Subject: AP1000 COL Response to Requests for Additional Information (TR 3)

RAI Response Number: RAI-TR03-015

AP1000 TECHNICAL REPORT REVIEW

Figure RAI-TR03-15-1-Strain-iterated shear wave velocity profiles

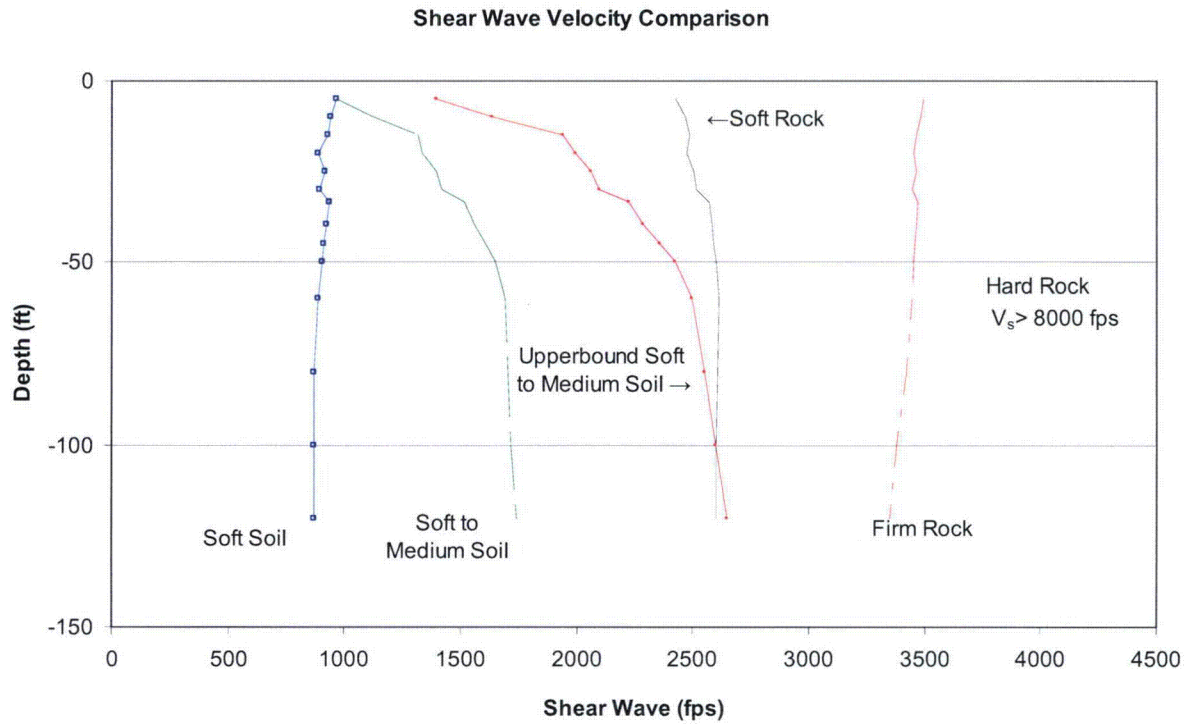
In Page 48 of 154, Westinghouse illustrated that some effects (water table, soil layering, soil degradation model, etc.) are not significant to the seismic response of the nuclear island (NI) structures. Because these results are applied for the AP1000 design, the staff requests Westinghouse provide technical basis for making these conclusions. In addition, Westinghouse needs to demonstrate the combination of these effects is also insignificant to the seismic response of the NI structures.

Westinghouse has addressed soil degradation in RAI-TR03-10. Tables of strain-iterated shear wave velocity used in the generic analyses are shown. Figure RAI-TR03-15-1 shows the bounds of these strain-iterated shear wave velocity profiles. The combination of effects of the different soil parameters is reflected in these bounds. Figure RAI-TR03-15-2 shows how a COL applicant could demonstrate that the site is enveloped by generic seismic design basis. The applicant would define its site geotechnical parameters as defined in DCD Section 2.5 and in a foundation interface report in which the applicant would make its case of why the site is within the bounds of the AP1000 generic analyses that have been considered in this technical report. These parameters would include the soil profiles used in the PSHA analyses, which

Figure RAI-TR03-022-1-Relative Displacement of Node 3360, top of Shield Building

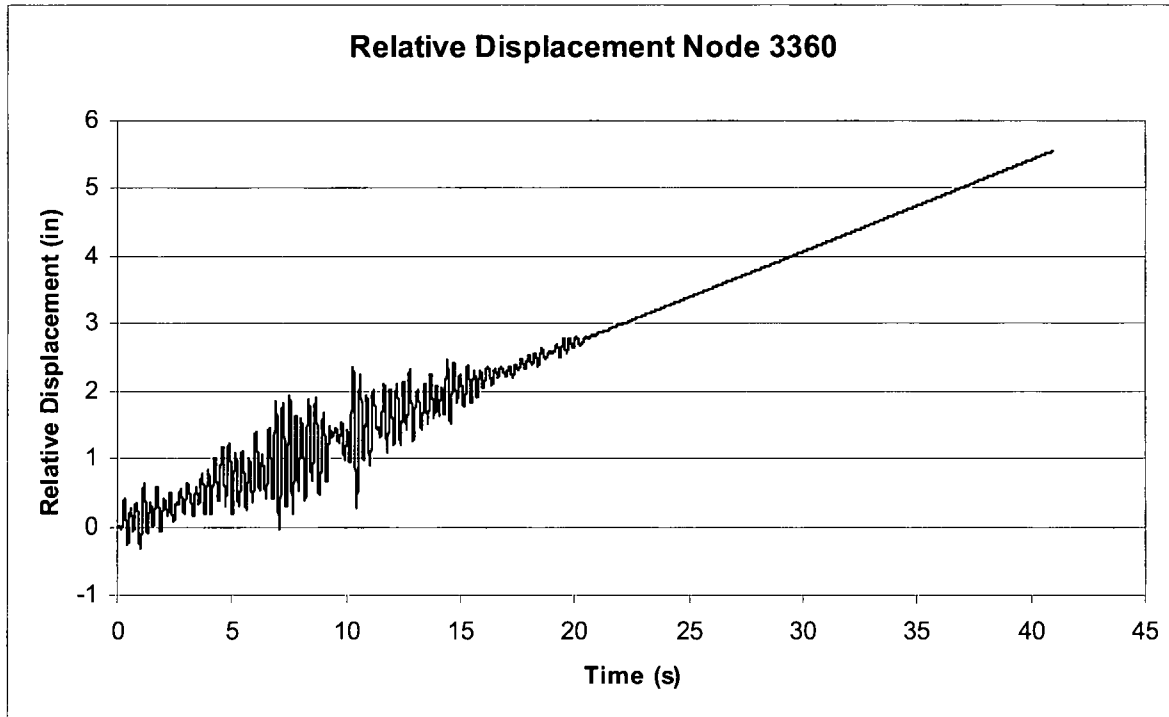
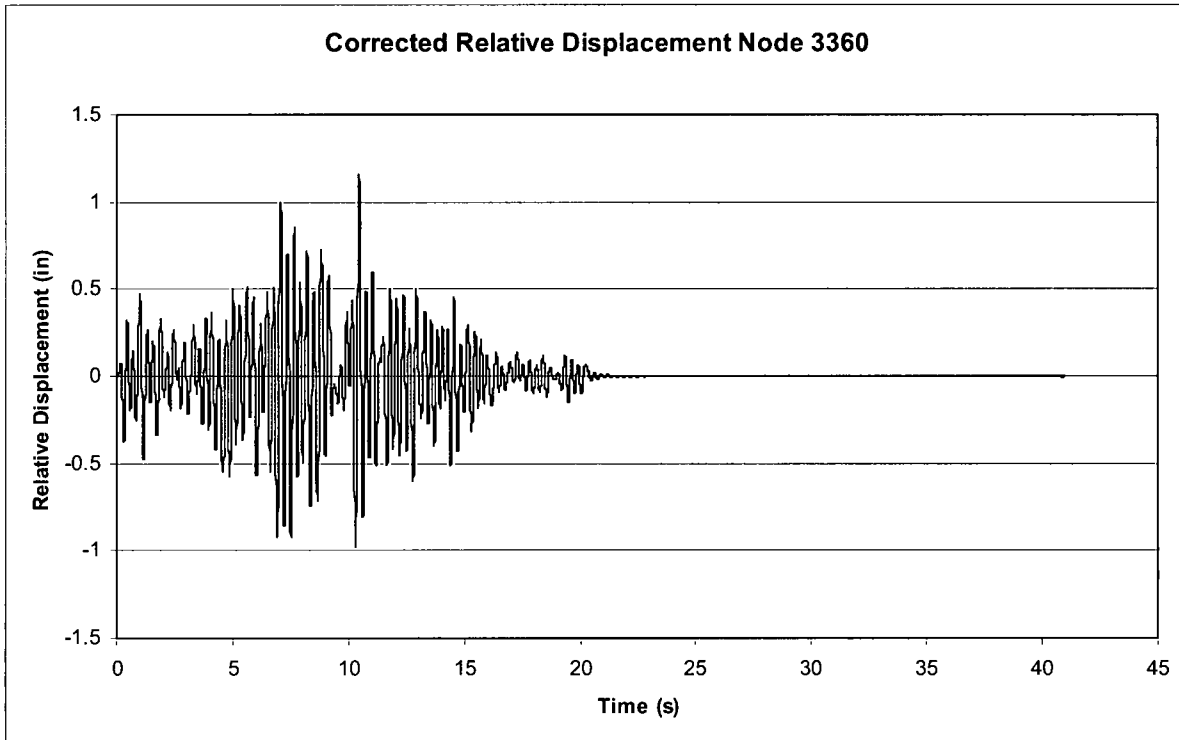
- a. Are the deflections in the tables a consistent set, based on the worst-case time history result, or are they an envelope of maximum deflections from all the time history results?
- b. How do these tabulated deflections compare to the corresponding deflections obtained from the equivalent static acceleration analyses? Please provide a tabulated comparison, and an explanation of any significant differences.

- a. Deflections have been developed using the model with the robust shield building design. These displacements for the soil and hard rock cases have been obtained relative to the translation of a reference node at the bottom of the foundation and near the center of the basemat. Coordinates of this reference node are $x = 993.00$ ft, $y = 986.00$ ft and $z = 60.50$ ft. The deflections have been revised to remove drift. The absolute displacement time histories are calculated from the nodal time histories accelerations. When the relative displacements are plotted there is a constant slope as shown in Figure RAI-TR03-022-1. To correct this drift, the slope of the relative displacement multiplied by the time is subtracted from the relative displacement at each time step. Presented in Figure RAI-TR03-022-2 is the drift corrected relative displacement.

Figure RAI-TR03-032-1 — FRS Comparison at Base of SCV on CIS at RPV Center

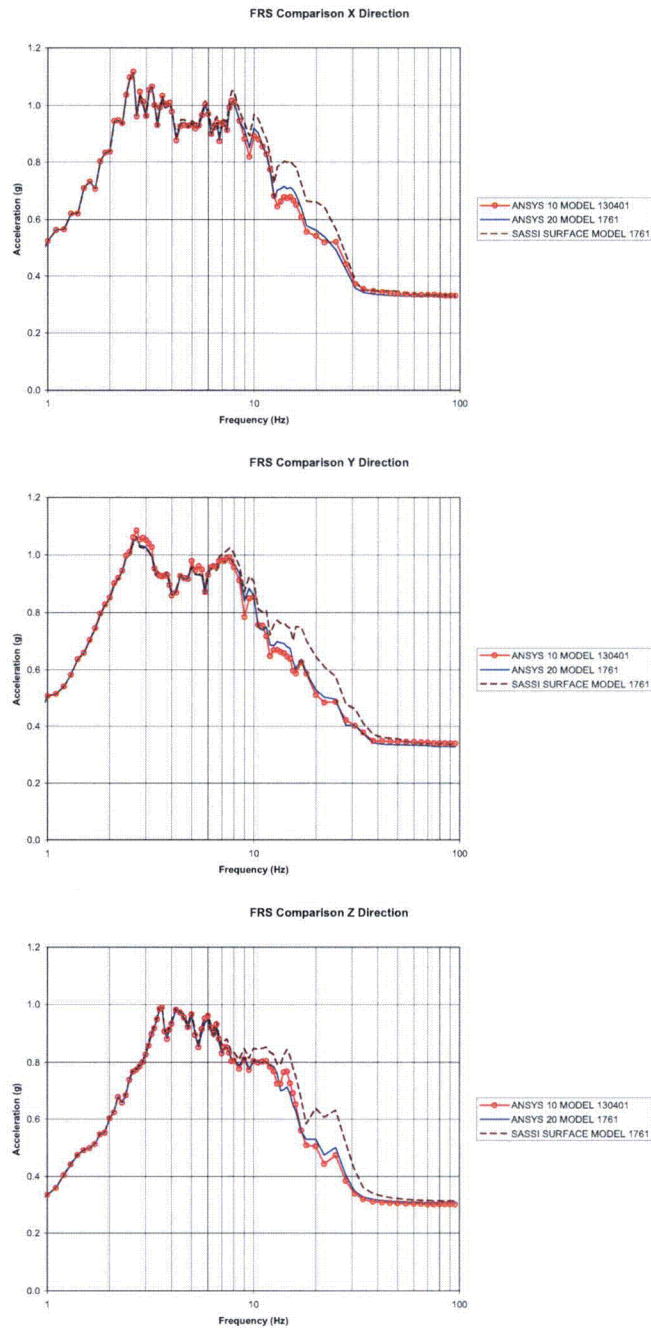
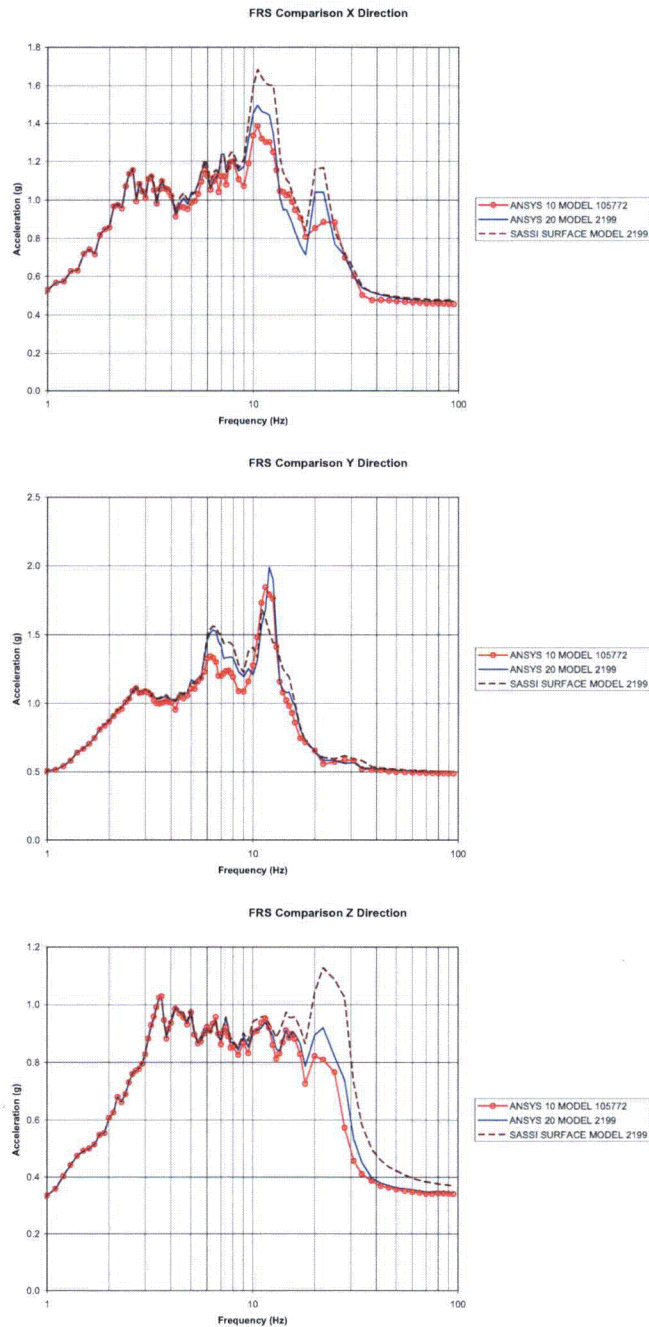
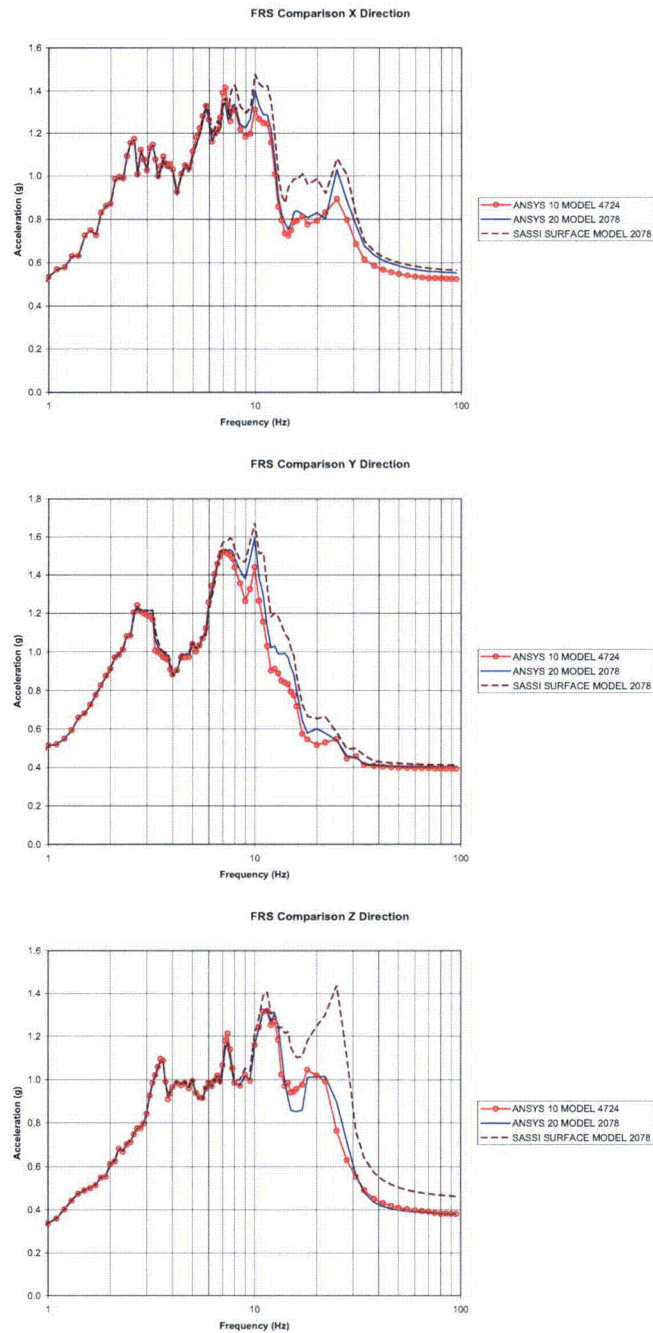
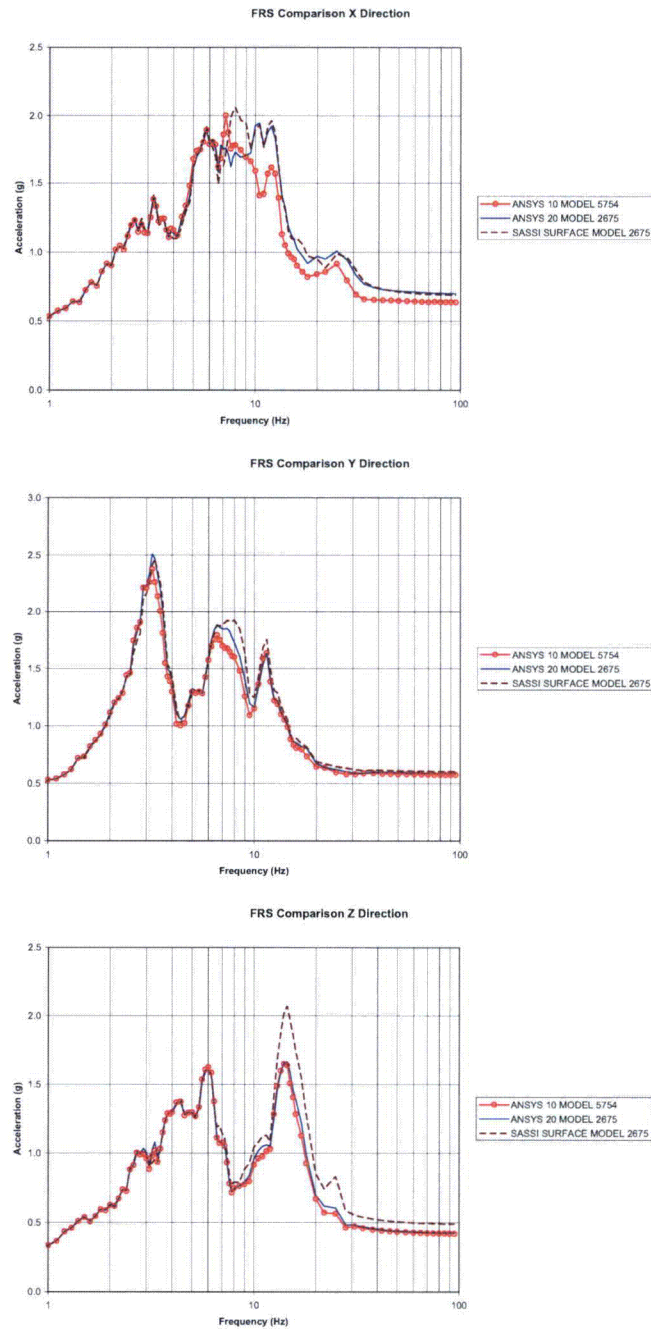
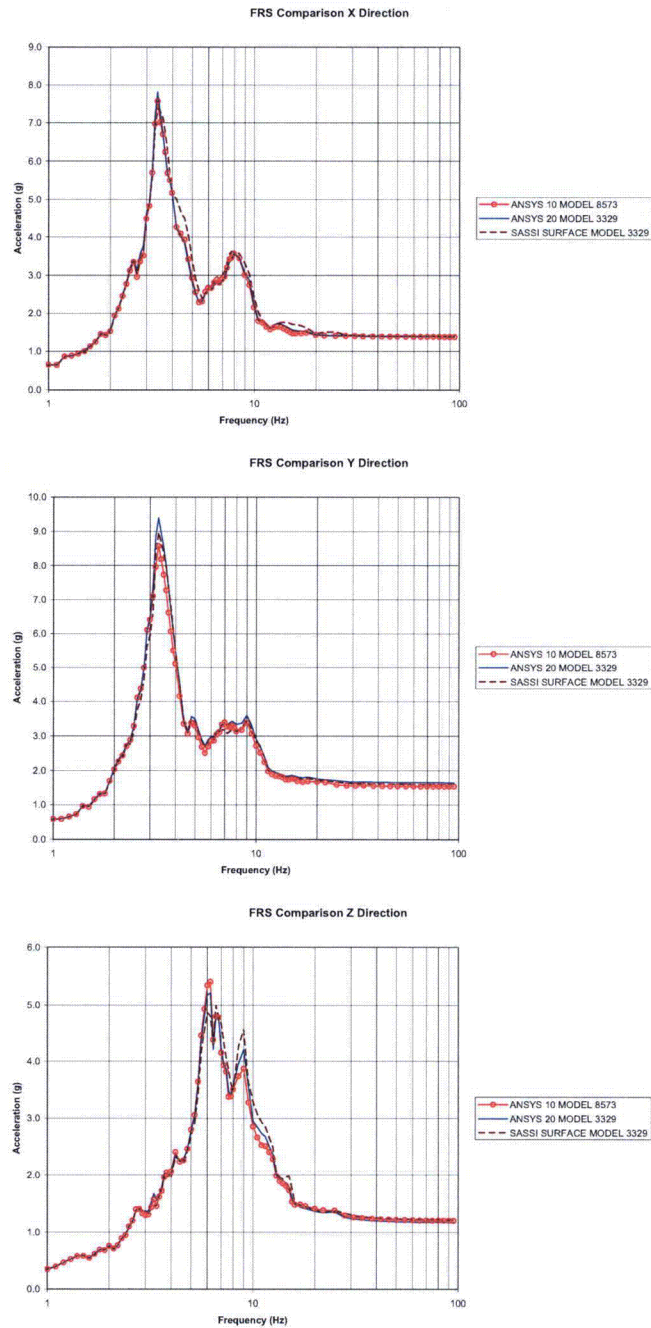
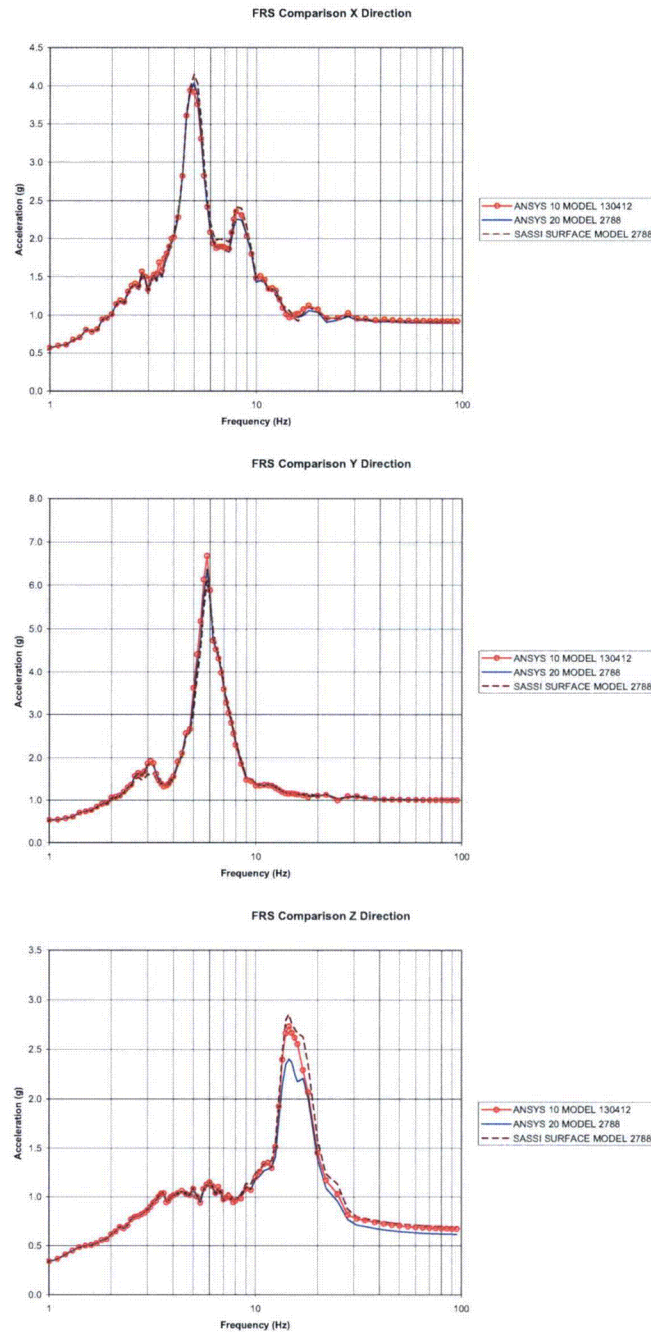
NI20 model results above 10 hertz for all site conditions, including a hard rock site. Is the NI20 grid sufficiently refined to accurately predict response above 10 hertz? Have any SASSI soil site analyses been performed using a refined grid comparable to the NI10 model, to study the effect of element size on the solution results?

- c. Explain what studies were performed to establish that the NI10 model refinement is sufficient to accurately account for high frequency response effects at all critical locations. It is not obvious from the results shown in Figure C-1 that convergence with element size has been achieved.

- c) The NI10 model is described in DCD subsection 3.7.2 (Item 5) and is the basis for the vertical floor response spectra for hard rock. The model was reviewed and accepted as part of the hard rock design certification. During development of the model detail studies with greater element refinement were performed for the floor above the control room and the adjacent bays to confirm the adequacy of the model.

Location	NI10 Node	NI20 Sassi	Figure ANSYS & SASSI FRS Comparaison	General Area	Elevation (feet)
CIS at Reactor Vessel Support Elevation	130401	1761	RAI-TR03- 032-1	RPV Center	100.00
CIS at Operating Deck	105772	2199	RAI-TR03- 032-2	SG West compartment, NE	134.25
ASB NE Corner at Control Room FloorCeiling	4724	2078	RAI-TR03- 032-3	NE Corner	116.50
ASB Corner of Fuel Building Roof at Shield Building	57454	2675	RAI-TR03- 032-4	NW Corner of Fuel Bldg	179.19
ASB Shield Building Roof Area	8573	3329	RAI-TR03- 032-5	South side of Shield Bldg	327.40
SCV Near Polar Crane	130412	2788	RAI-TR03- 032-6	SCV Stick Model	224.00
